# **ANA Garrison at Kunduz Does Not Meet All Quality and Oversight Requirements; Serious Soil Issues Need to Be Addressed**

SIGAR Audit-10-09

## ANA Garrison at Kunduz Does Not Meet All Quality and Oversight Requirements; Serious Soil Issues Need to Be Addressed

SUBJECT: USACE Response to Special Inspector General Draft Report for Afghanistan Reconstruction SIGAR audit 10-09, Contract Performance Oversight, ANA Garrison at Kunduz Does Not Meet All Quality and Oversight Requirements; Serious Soil Issues Need to Be Addressed.

**Figure 2: Master Plan of Kunduz ANA Garrison, Phase I**

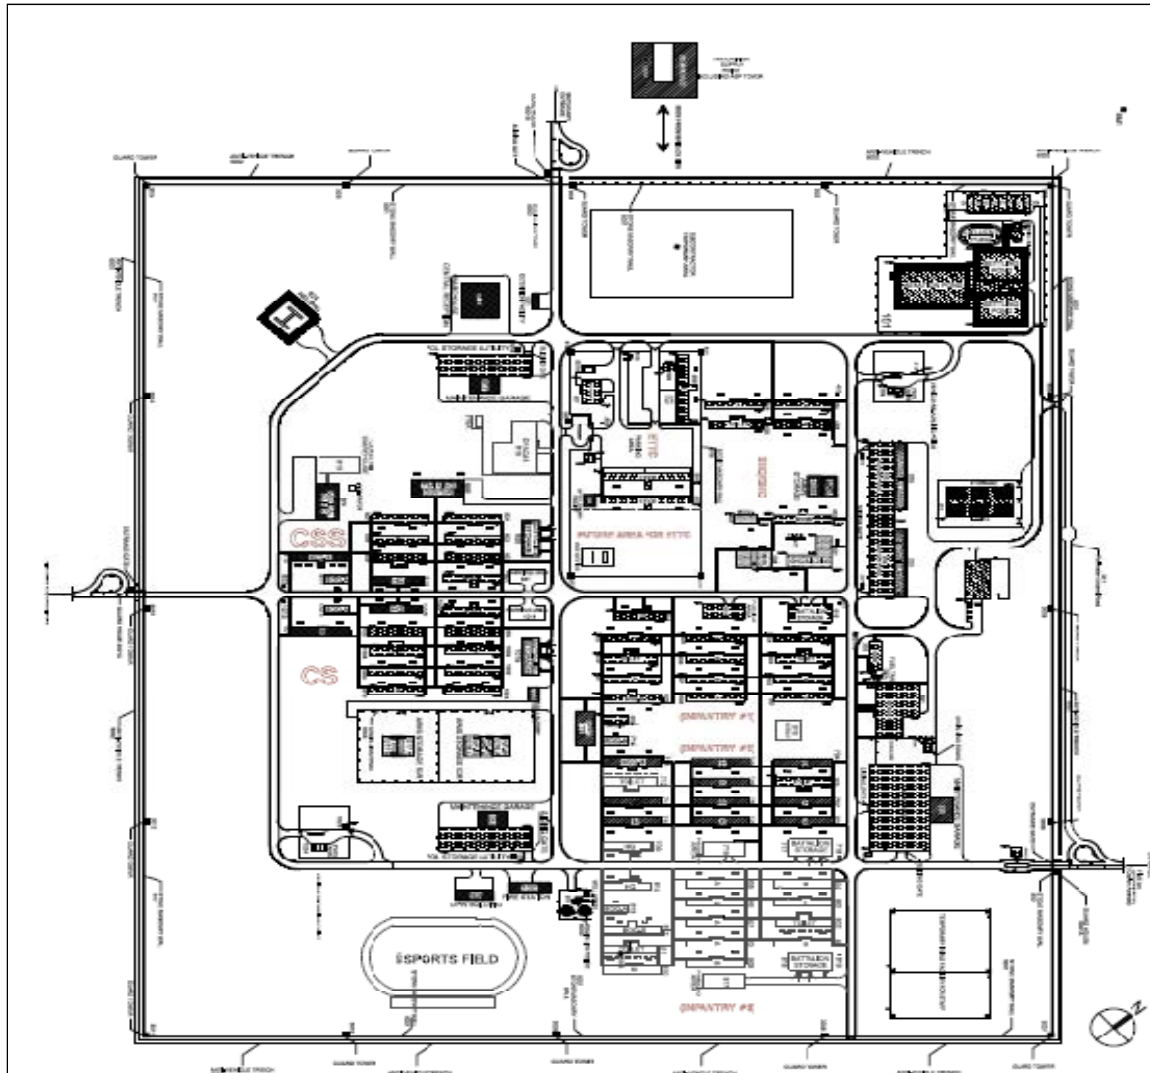
*"As shown in figure 2, the master plan details two phases ...."*

The diagram does not show Phase I and Phase I. Recommend replacing Figure 2 with the diagram that depicts all phases.

5. We modified the report to indicate that the diagram shown in figure 2 does not show Phase II of the Kunduz ANA garrison.
6. We modified the report to indicate that current plans call for housing German soldiers at the embedded training team compound.
